BCA ASSESSMENT REPORT

**PRECINCT 3
Oakdale East Estate, Horsley Park**

**Prepared For:
Goodman Property Services (Aust) Pty Ltd**

Revision 4

Fig.1 Rise in Storeys Calculation

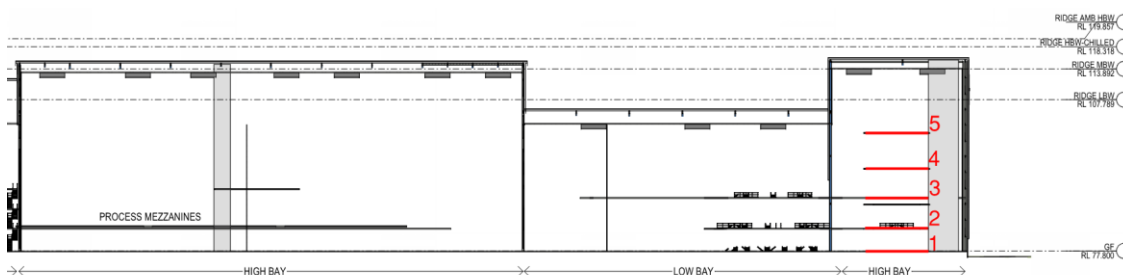
Comments: For a Large Isolated Building, the Type of Construction is determined by the rise in storeys (ie. 2 storeys = Type C; 3 storeys = Type B; & 4 storeys or greater = Type A). In relation to a Class 7b/8 building, Clause C1.2(c) states that any storey with an average internal height of >6m must be counted as 2 storeys (not 1).

The current design includes both stacked Mezzanine levels along with single Mezzanine levels where the average height is greater than 6m below and above the Mezzanine floors. This design will result in minimum Rise in Storeys of five (5).

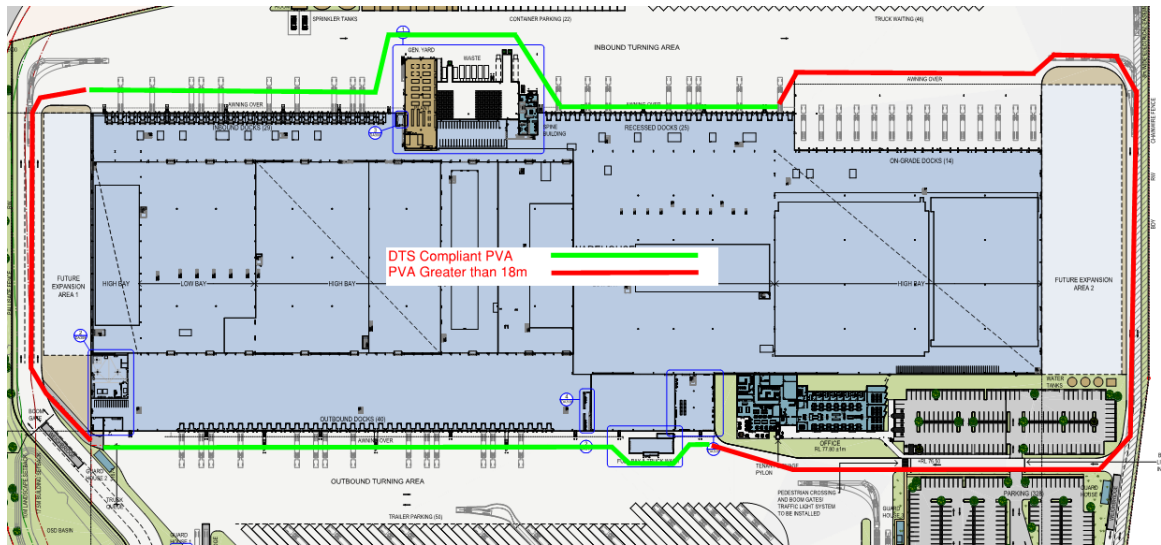
Comments: The proposed warehouse building is required to be sprinkler protected and provided with a 6-meter-wide perimeter vehicular access in accordance with Clause C2.4 throughout (see notes below). This designation allows for a fire compartment of unlimited size within the buildings. See further mark ups under C2.4 below with red lines showing non-compliant PVA.

Comments: The proposed building complies with the provisions of C2.4, with the exception of the following non-compliances (shown in red on the mark-up below) that are required to be addressed as a performance solution by the Fire Engineer.

- The furthest part of the vehicular access path is greater than 18m from the external wall at the West Ambient Expansion Area.
- The furthest part of the vehicular access path is greater than 18m from the external wall at the East Chilled Expansion Area.
- The furthest part of the vehicular access path is greater than 18m from the external wall near the Outbound Expansion area at the North of the building.
